Report: Deficiency Report
Function: Test, Adjust, & Balance
Date: 05/19/2025
Completed By: National TAB

05-19-25 WAWA #8196 POTTSTOWN, PA

Issue List

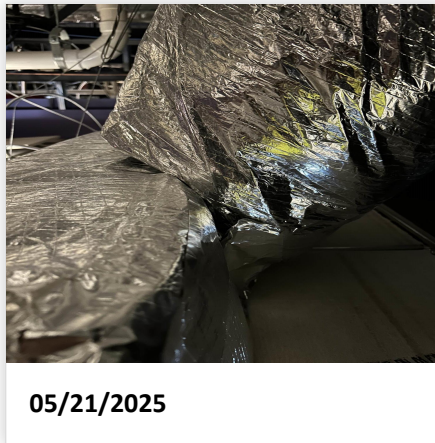
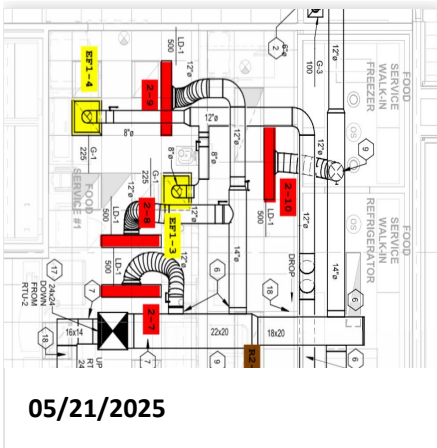
Issue Name : Diffuser 2-10 - Low Flow
Description : Diffuser 2-10 (food service) is currently at 343 CFM (69% design). Damper is fully open. Ductwork appears to be restricted at the diffuser takeoff. All other diffusers for RTU 2 are within design, and further balancing is not expected to improve this diffuser’s airflow to design. Recommend mechanical inspection.
Created By : National TAB **Assigned To :** National TAB - Will Turnbough
Status : Open
Priority : High **Asset Tag :**
Originated Date : 05/21/2025 - Mark Johnson - National TAB

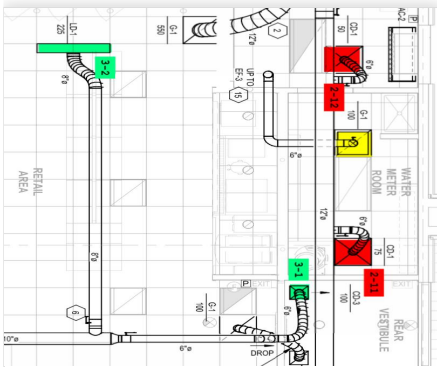
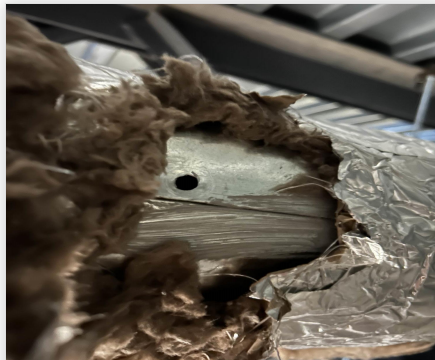
Issue Name : Diffuser 3-1 - Broken Damper
Description : The damper handle for diffuser 3-1 (rear vestibule) was broken while attempting to adjust. Damper blade is stuck and will not close sufficiently to adjusted the diffuser to design airflow. Diffuser is currently at 125 CFM (125% design) and cannot be adjusted further. Recommend damper repair.
Created By : National TAB **Assigned To :** National TAB - Will Turnbough
Status : Open
Priority : High **Asset Tag :**
Originated Date : 05/21/2025 - Mark Johnson - National TAB

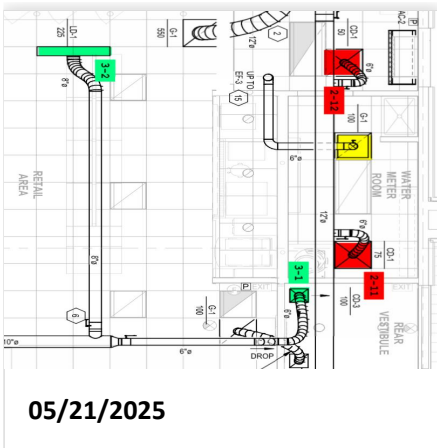
Issue Name : Diffuser 3-2 - Low Flow
Description : Diffuser 3-2 (retail area) is currently at 184 CFM (82% design). Damper is fully open and no ductwork deficiencies were noted. Not anticipated to cause comfort issues in the open retail space; however, it is expected that correcting the damper issue with diffuser 3-1 and closing it to design will improve this diffuser's airflow to be within design.
Created By : National TAB **Assigned To :** National TAB - Will Turnbough
Status : Open
Priority : Medium **Asset Tag :**
Originated Date : 05/21/2025 - Mark Johnson - National TAB
